35/131-07C 37 LENOX ST
Chevy Chase Village Historic District

PROPOSED FRONT ELEVATION
 MUSE ARCHITECTS
 JUNE 16, 2008

From: Joshua Hill [jhill@musearchitects.com]
Sent: Monday, June 23, 2008 4:53 PM
To: Fothergill, Anne
Subject: 37 West Lenox Street
Attachments: 37 W LEnox.JPG; Powell_FrontA.jpg; Powell_FrontB.jpg

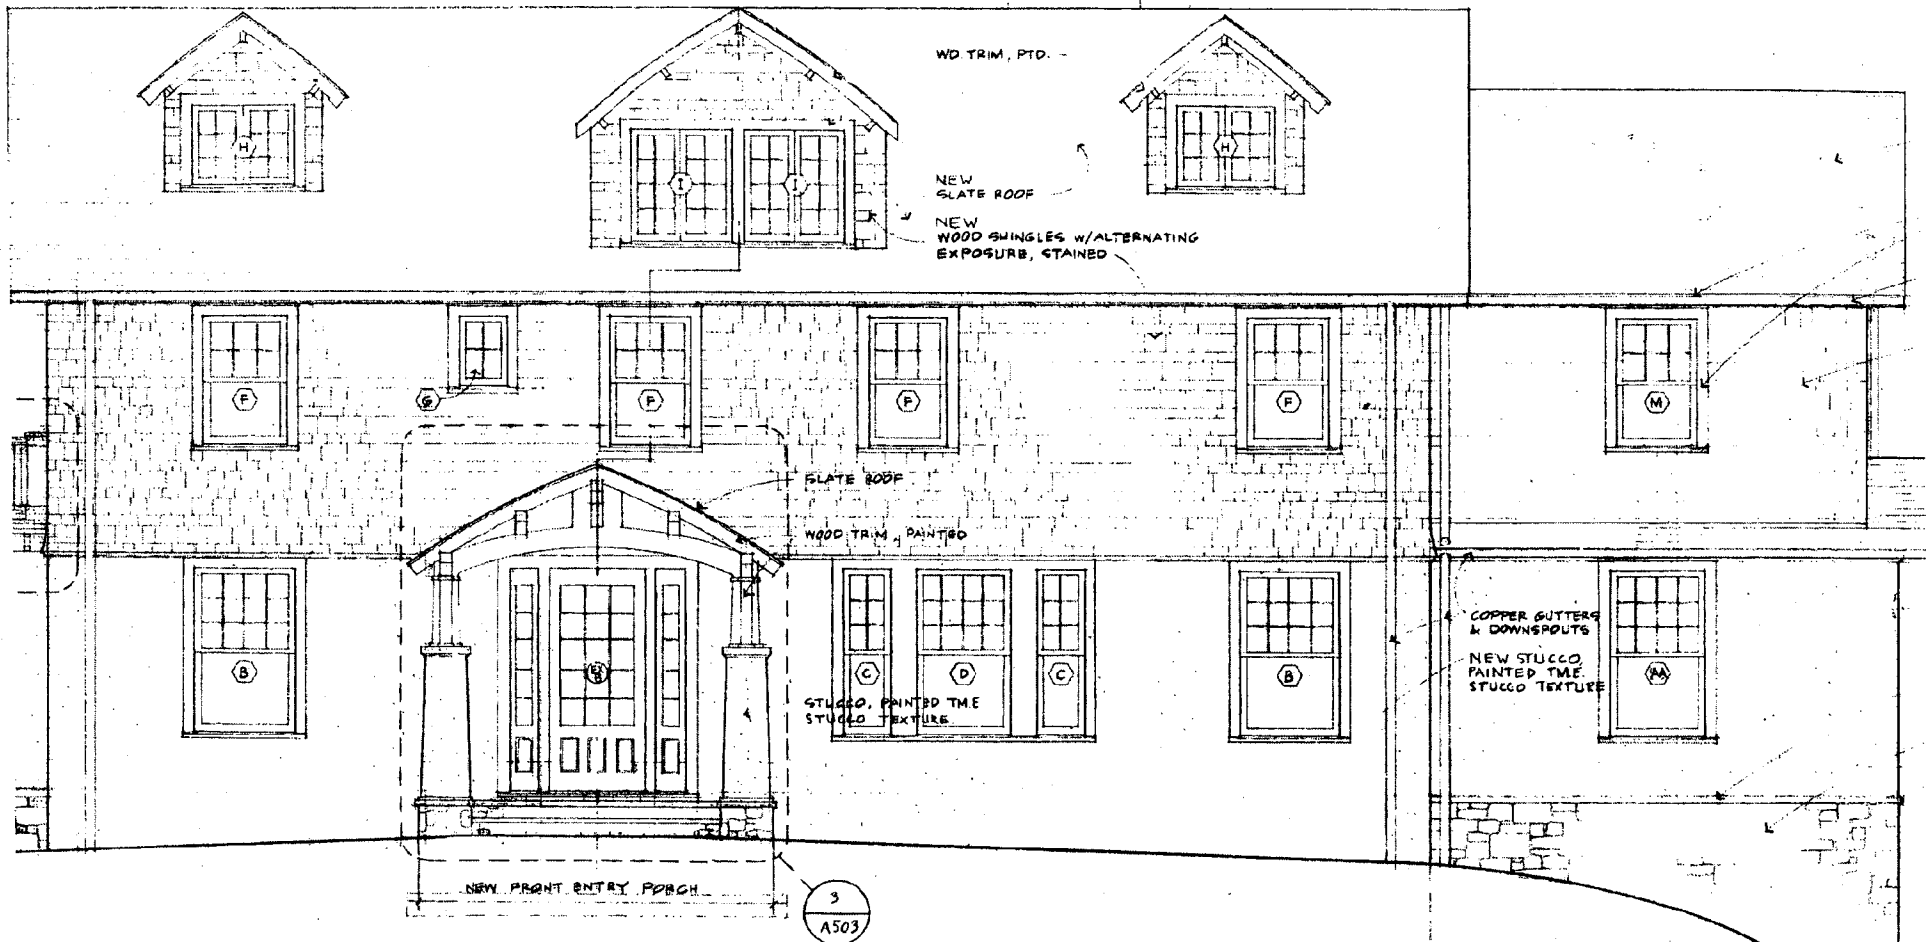
The project at 37 West Lenox Street is under construction, and we have made an interesting discovery. The pair of windows on the east side of the front elevation does not appear to be original judging by the size of the opening that they were framed into and the condition of the framing below the windows which appears to be newer (see attached photo).

It appears that this pair of smaller windows was added so that the previous owner could have a desk in this location and use this part of the house as a study. The new owners are using this smaller space and the space next to it as one large space - the dining room for the house. Since these windows are not original and the use of the space has changed, we think this would be a good opportunity to install a new window in this location that matches the other windows on the front elevation and better fits the new use of the space. The new window will be a custom window to match the existing windows on the house and it will be the same size as the other first floor windows on the south elevation. This window will only have muntin divisions in the top sash while leaving the bottom sash open without divisions, matching the original windows on the house.

Please review the attached drawings and let us know your thoughts.

APPROVED
 Montgomery County
 Historic Preservation Commission

6-26-08

ORIGINAL WALL (RED-DASHED) IS 40 LINEAL FEET FROM POINTS A TO C

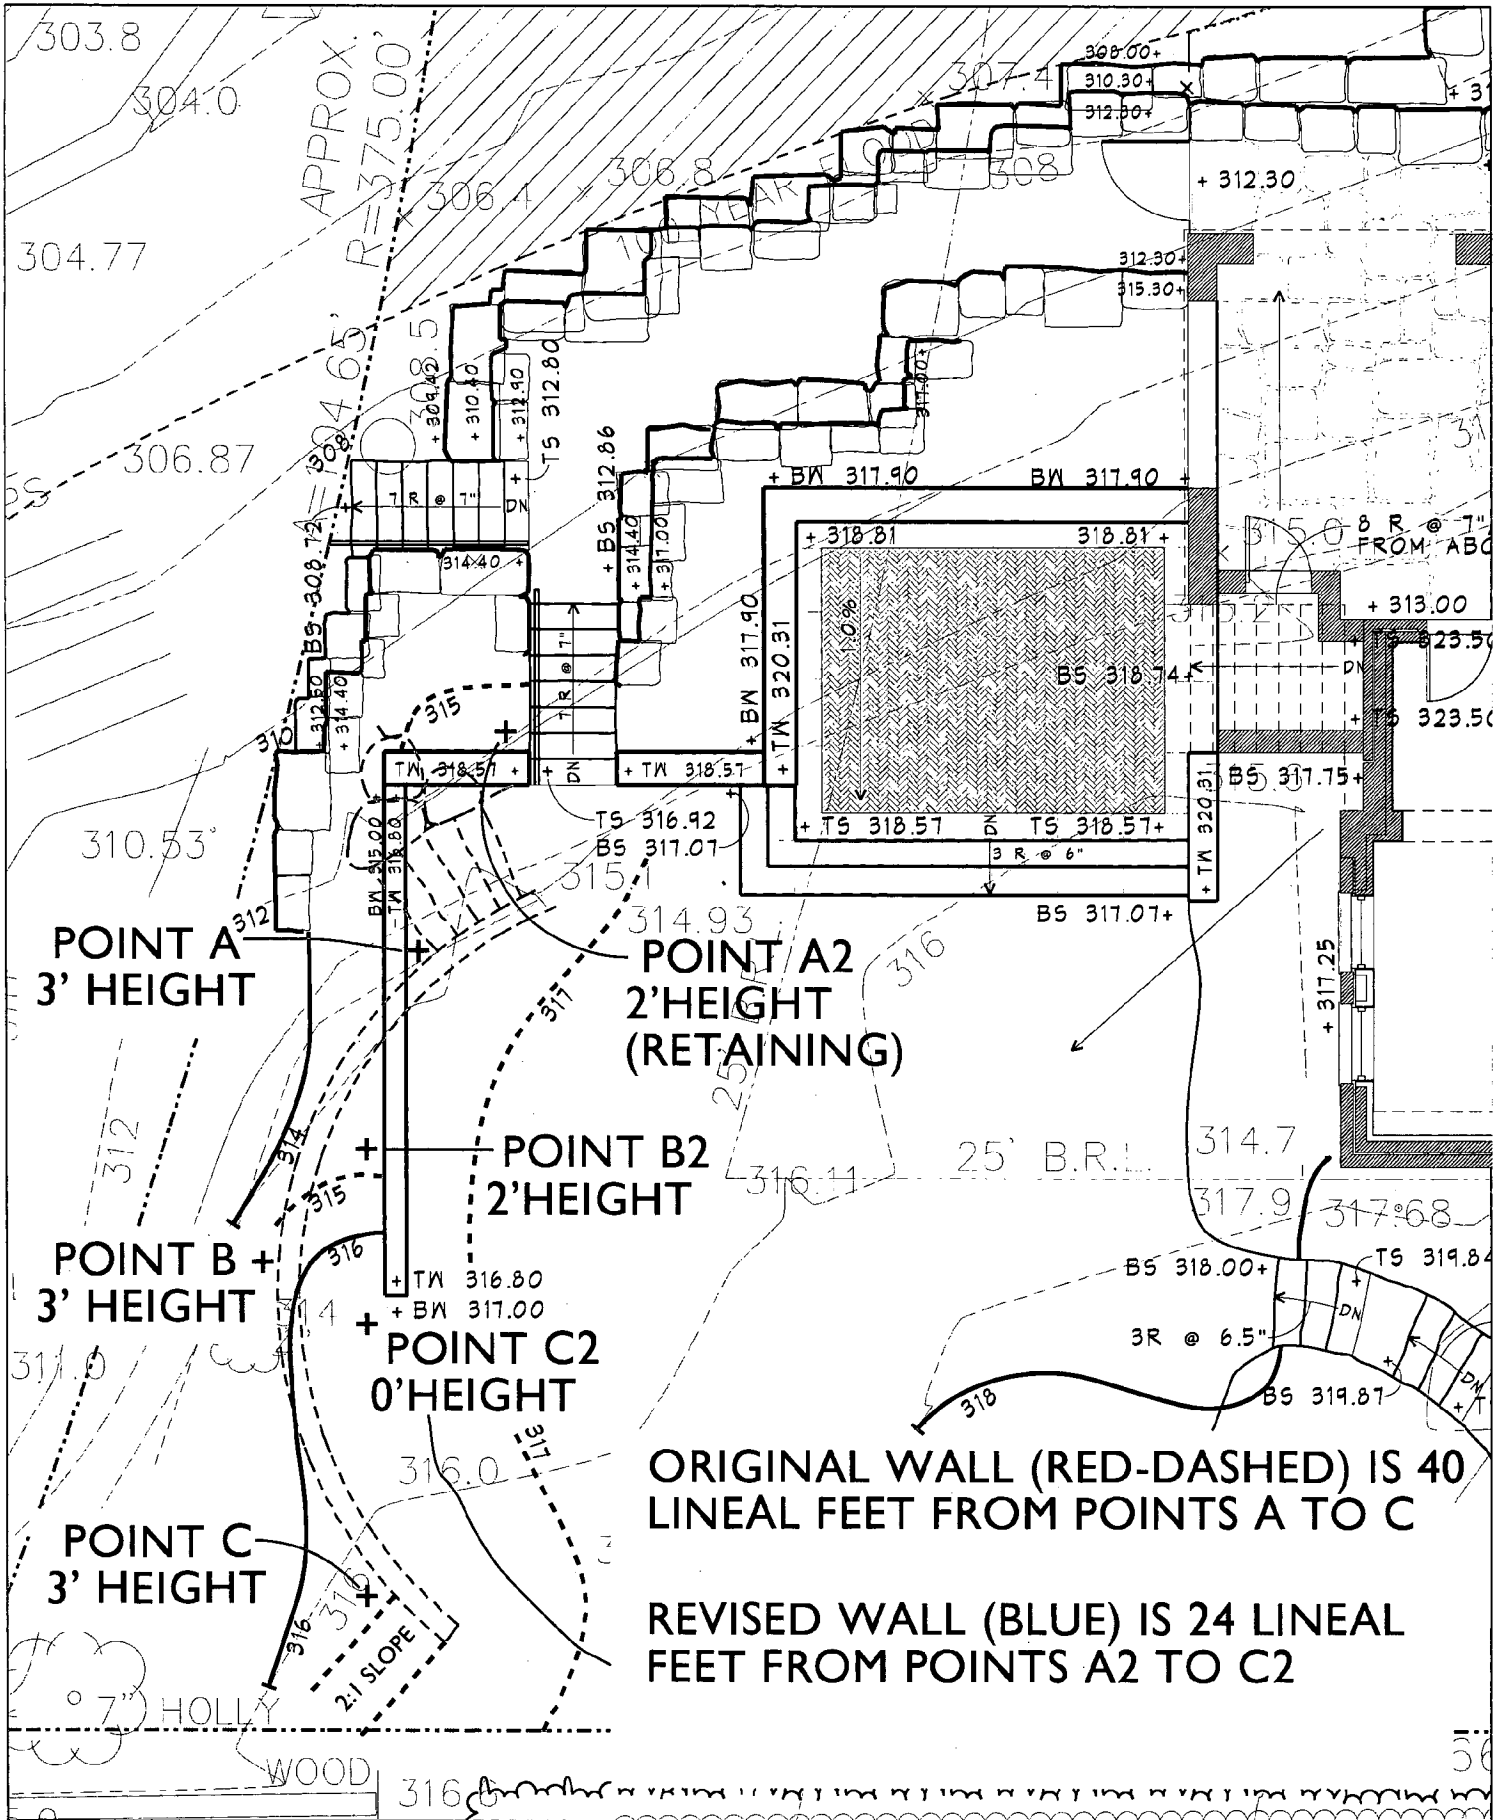
REVISED WALL (BLUE) IS 24 LINEAL FEET FROM POINTS A2 TO C2

I am sorry for the confusion. It is the WEST wall that is in question. The EAST wall has not changed at all. It is in the same location at the same heights, the same materials and the same length.

We have attached an analysis sheet for the WEST wall that I hope helps to illustrate our efforts to minimize the impact of the wall on the site.
